**From:** Wesley Held  
**To:** <arspears@southernco.com>, <jtdavis@southernco.com>  
**Date:** 8/31/2007 4:05:06 PM  
**Subject:** Section 2.5 Part 1 of SER  
**cc:** "Christian Araguas" <CJA2@nrc.gov>

## **2.5 Geology, Seismology, and Geotechnical Engineering**

In Section 2.5, “Geology, Seismology, and Geotechnical Engineering,” of the VEGP SSAR, the applicant described geologic, seismic, and geotechnical engineering properties of the VEGP ESP site. SSAR Section 2.5.1, “Basic Geologic and Seismic Information,” presents information on geologic and seismic characteristics of the VEGP site and region surrounding the site. SSAR Section 2.5.2, “Vibratory Ground Motion,” describes the vibratory ground motion assessment for the ESP site through a PSHA and develops the SSE ground motion. SSAR Section 2.5.3, “Surface Faulting,” evaluates the potential for surface tectonic and non-tectonic deformation at the ESP site. SSAR Sections 2.5.4, “Stability of Subsurface Materials and Foundations,” 2.5.5, “Stability of Slopes,” and 2.5.6, “Embankments and Dams,” describe foundation and subsurface material stability at the ESP site.

**Figure 2.5.2-15 - Results of the staff's site response calculations for high-frequency rock motions for the 10<sup>-4</sup> hazard level. The applicant's mean results are shown for comparison.**

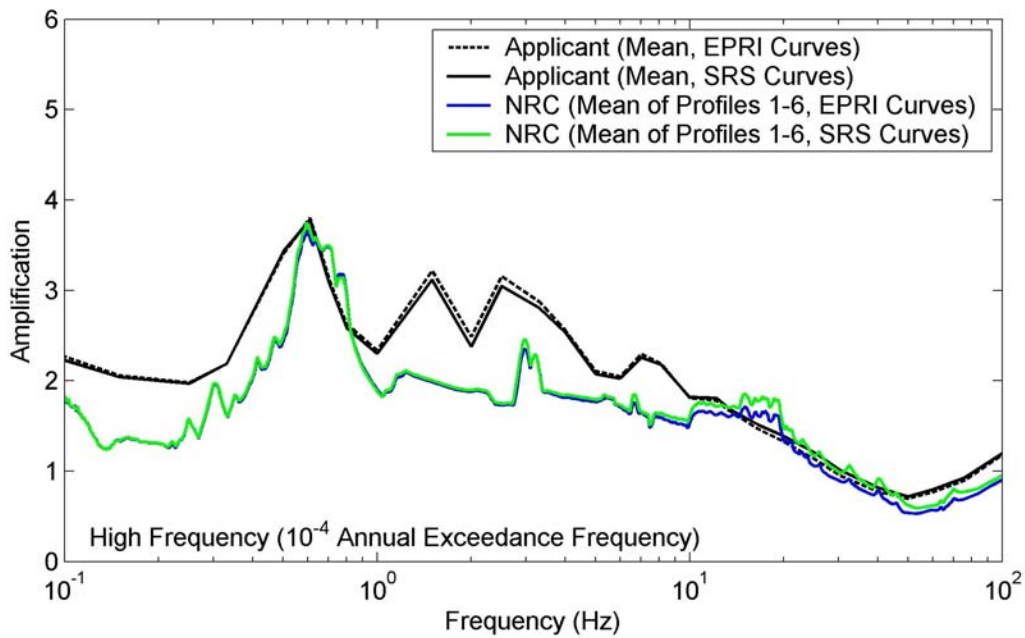
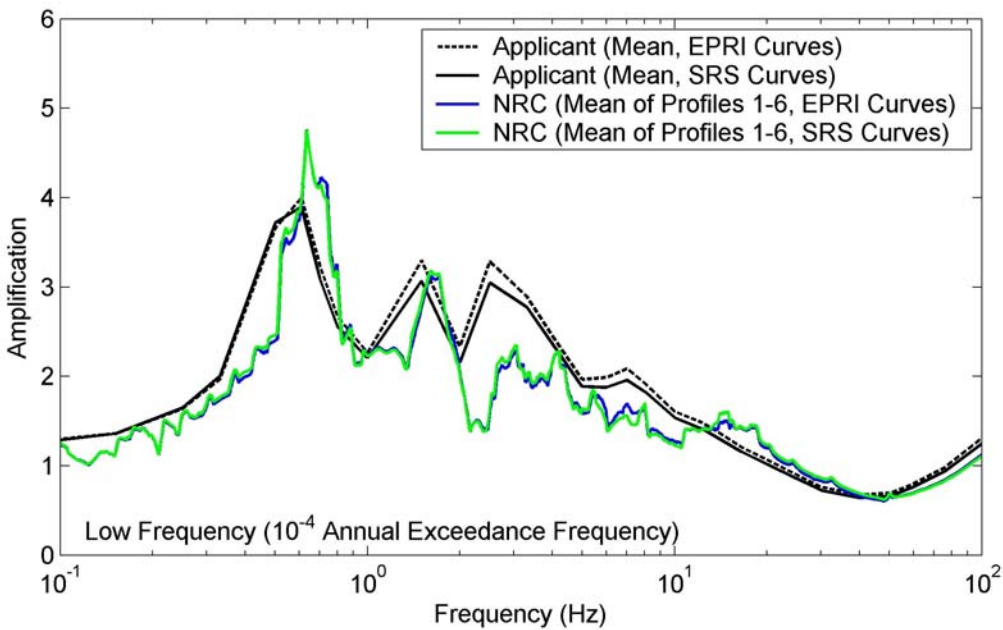
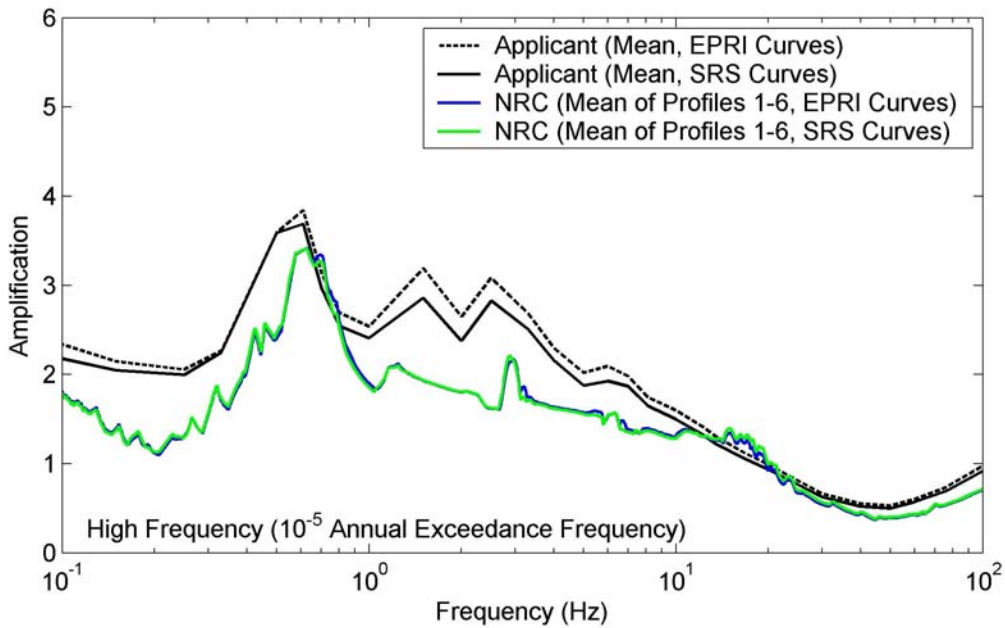
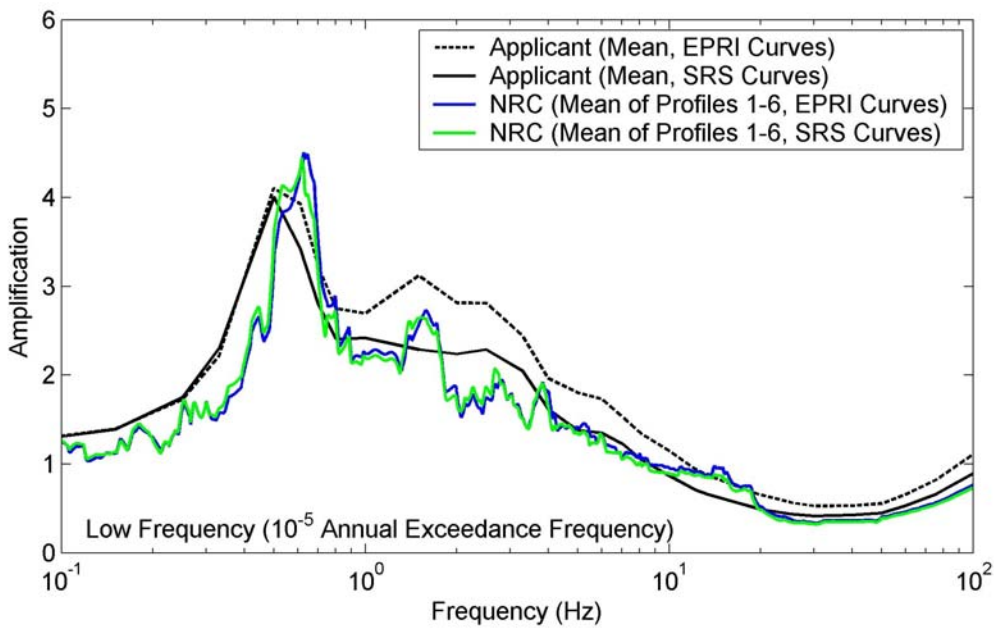
SER Figures 2.5.2-15 to 2.5.2-18 show the mean AFs resulting from the staff's confirmatory site response calculations. Each figure plots the mean results of the six alternative subsurface profiles for both the EPRI and SRS shear modulus and damping curves. SER Figures 2.5.2-15 and 2.5.2-16 show the results corresponding to the  $10^{-4}$  hazard levels for the respective high- and low-frequency input motions, while SER Figures 2.5.2-17 and 2.5.2-18 plot the results corresponding to the  $10^{-5}$  hazard levels for the respective high- and low-frequency input motions. SER Figures 2.5.2-15 to 2.5.2-18 also show the applicant's mean AFs for comparison. The applicant's results are similar overall. For each case, the amplification peaks are very similar, and in all cases, the peaks occur at approximately 0.6 Hz.

The differences between the results are likely due to the greater variability that the applicant incorporated into its model through the use of randomized profiles and material properties, as well as the use of multiple time histories. This variability is illustrated in SER Figure 2.5.2-19 (reproduced from SSAR Figure 2.5.2-37). As a result of its analysis, the staff was able to confirm the applicant's overall site response results.
